**NW Natural Pre-Remedial Design Data Gaps Sampling  
B1 Navigation Channel Project Area – Fall 2020  
Field Change Request Form**

**Field Activity:** Surface Sediment Sampling      **Request Number:** 2

**Field Change Request (FCR) Title:** Additional Surface Sediment Grab Collection and Analyses for Sediment Management Areas Refinement

**Figure 1**  
**Proposed Additional Surface Sediment Grab Locations (Downriver Portion)**

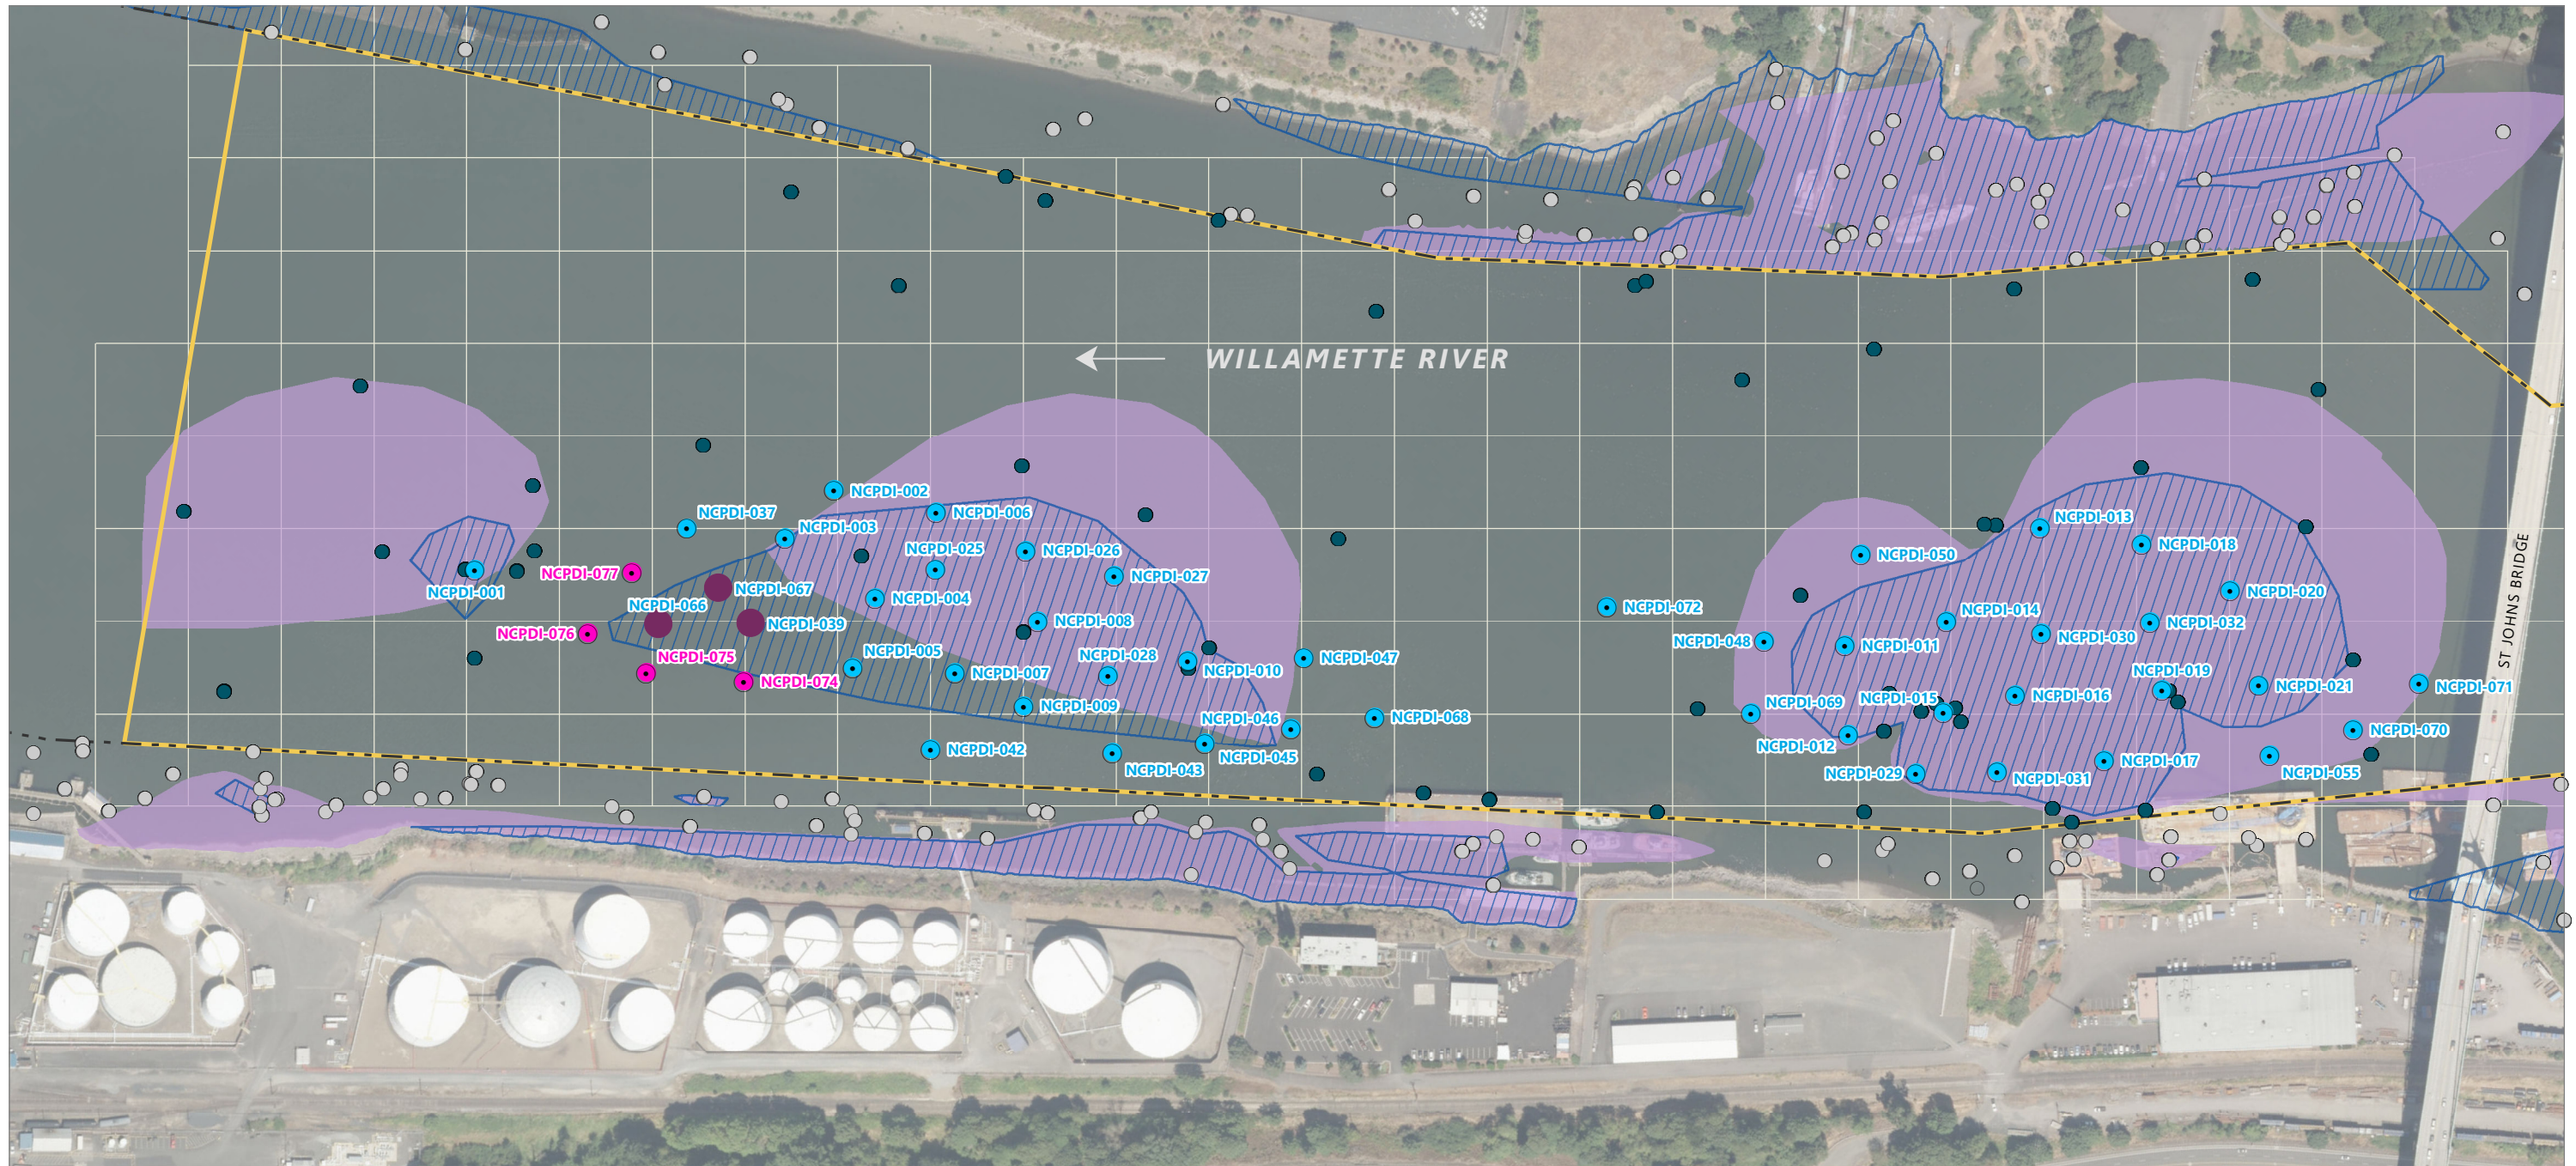
<b>Description</b>
<p>Starting in September 2020 and continuing to date, NW Natural has been conducting pre-remedial design investigation activities in the Navigation Channel Project Area (Project Area) in accordance with the U.S. Environmental Protection Agency (EPA)-approved <i>Revised Final Pre-Design Investigation Work Plan</i> (PDIWP). As discussed in Section 3.3 of the PDIWP, the surface sediment grabs are being collected and analyzed to refine the sediment management areas (SMAs) within the Project Area based on the exceedance of the Record of Decision (ROD) Table 21 remedial action levels (RALs) and principal threat waste (PTW)-highly toxic thresholds. As shown in Figure 1, surface sediment grab concentration exceedances of the ROD Table 21 RALs and PTW-highly toxic thresholds were detected at three surface sediment grab stations (purple circles in Figure 1) along the outermost perimeter of one of the Project Area SMAs where no contingency surface sediment grab samples were proposed in the PDIWP. NW Natural proposes additional surface sediment grabs nearshore and downriver of these three stations to attempt to laterally bound the exceedances. Sampling and analysis will be completed in accordance with the PDIWP and compared against the ROD Table 21 RAL and PTW-highly toxic thresholds.</p>

<b>Recommended Change</b>
<p>NW Natural proposes to collect four additional perimeter surface sediment grabs (NCPDI-074 through NCPDI-077) at the stations shown in Figure 1 with the geographic coordinates provided in Table 1 to attempt to laterally bound the surface sediment SMA boundary.</p>
